UNITED STATES  
NUCLEAR REGULATORY COMMISSION  
WASHINGTON, D.C. 20555-0001

SAFETY EVALUATION REPORT

Docket No. 72-1026  
FuelSolutions™ Storage System  
Certificate of Compliance No. 1026

**Figure 4-1: Design Basis Storage System Heat Balance**

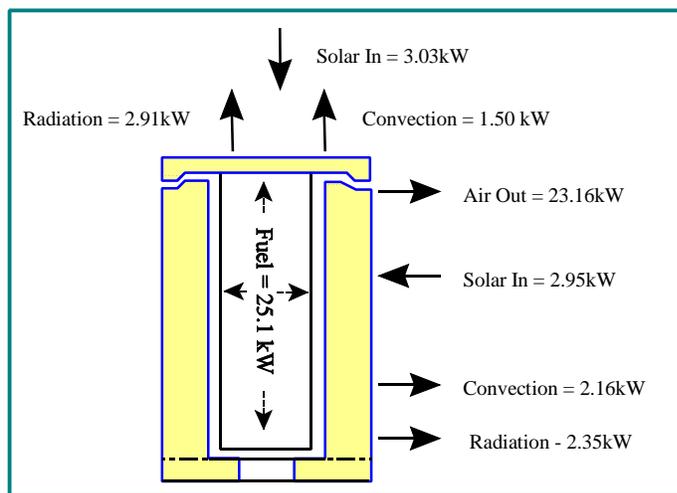
With respect to the design of the overpack, the internal air passage between the canister and the overpack inner surface provides the primary means for decay heat removal. Approximately 75% percent of the heat generated in the canister plus the solar heat on the overpack is removed through the air passage (see Figure 4-1). This heat removal is accomplished through natural convection cooling. The cooling is passive in that it uses differential air density buoyancy (also characterized as the chimney effect) to drive the air flow up the passage between the canister outer wall and the concrete overpack inner surfaces.

**Figure 4-2: Transfer Cask Heat Balance Illustration**

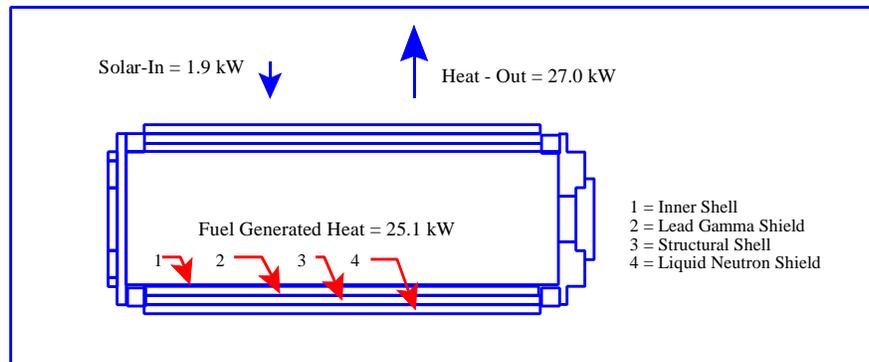
Figure 4-2 illustrates the heat balance within the transfer cask at normal hot conditions for the W21 canister.

**Figure 4-3 Flow Pattern for Vertical Canister**

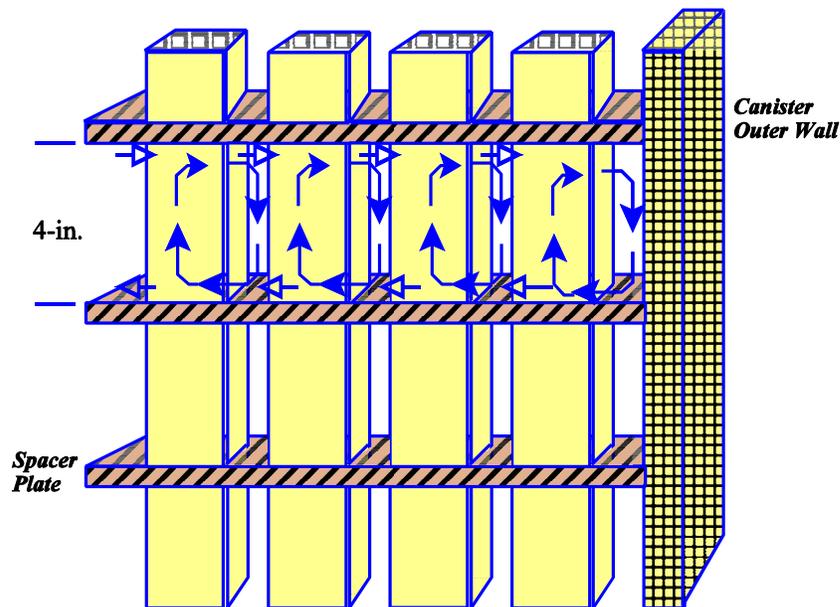
As addressed in Section 4.2.2 of this SER, helium backfill is used in the canister to optimize the heat transfer rate from the fuel to the canister wall and to provide an inert atmosphere to limit the potential for degradation of the internal components. The heat transfer effectiveness of the helium gas was demonstrated on full scale casks at the INEEL. However, the FuelSolutions Canister Storage System has one significant design difference when compared to the tested canisters. Spacers within the FuelSolutions canister limit the natural circulation of helium coolant to the distance between the spacers (e.g., natural convection does not flow from the bottom to the top of the cask outside the fuel assembly region, See Figure 4-3). This limits the buoyancy driving head that can influence the helium velocity. A lower buoyancy head can restrict the maximum velocity of the helium gas. A lower helium velocity has the potential for lowering the convective heat transfer rates. This issue led the staff to question the degree of natural circulation cooling provided in the FuelSolutions design and the ability of the vendor to adequately calculate the heat transfer and helium flow characteristics inside the FuelSolutions canister.

To resolve this technical issue, the staff, with the assistance of the PNNL, performed independent analyses using the COBRA-SFS computer code to augment the validation of the applicant's analytic conclusions. The COBRA-SFS computer code was validated with all of the spent fuel casks tested at the INEEL facility. The results of the COBRA-SFS and SINDA/FLUINT analyses are described in the following paragraphs.

Figure 4-4: COBRA-SFS Predictions of FuelSolutions W21 Storage System Radial Temperatures using BFS Level of Enhanced Heat Transfer Between Spacers

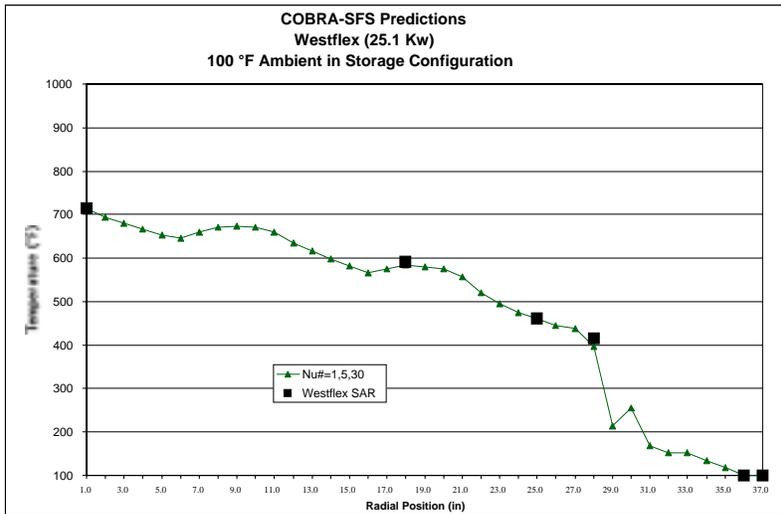
The COBRA-SFS model for the W21 canister was developed from the information presented in the SAR. Two base simulations (i.e., Cases 2 and 3) were performed. First a COBRA-SFS model was developed to treat the radial heat transfer in the regions between the horizontal spacer plates using a similar Nusselt number approach as applied by The applicant. This validated the staff's input model for COBRA-SFS code as providing similar results compared to the applicant's analyses. Next, although data exists for a range of spent fuel storage systems, there is no comparable full scale cask thermal performance data with multiple horizontal spacers, as designed into FuelSolutions. However, data for enhanced heat transfer due to natural convection between plates was identified by The applicant (e.g., Figures 4.4-4 and 4.7-5 in the WSNF-201 SAR). As an independent confirmatory calculation of the physics that exists in the FuelSolutions design, the staff requested PNNL to confirm, through detailed analyses, the thermal characteristics or response of the helium heat transfer mechanisms (e.g., flow and heat transfer rates) that occurs between the spacers.

The first base simulation (Case 2) COBRA-SFS model using the enhanced Nusselt number correlation in between the spacer regions duplicated the applicant's predictions extremely well. The results are presented in Figure 4-4. The radial temperatures are provided at the peak axial temperature level of the spent fuel cladding in the center assembly for all of the components, with the exception of the annulus temperatures, which represent the peak temperature of the flow field which occurs at the inner and outer annulus outlets. For simplicity, only a few points from the FuelSolutions SAR have been provided. Results from the second base simulation (Case 3) COBRA-SFS model are included and presented in Figure 4-5. The radial heat transfer coefficient of the gas between the spacers was treated with a Nusselt number of 3.66, with the exception of the single region that was nodalized in greater detail. It is projected that the peak temperature predicted by the COBRA-SFS model would approach the 715 °F predicted by the BFS model if the flow among all of the spacers was treated in a similarly detailed fashion. The staff, therefore, finds the thermal models used by the applicant acceptable.
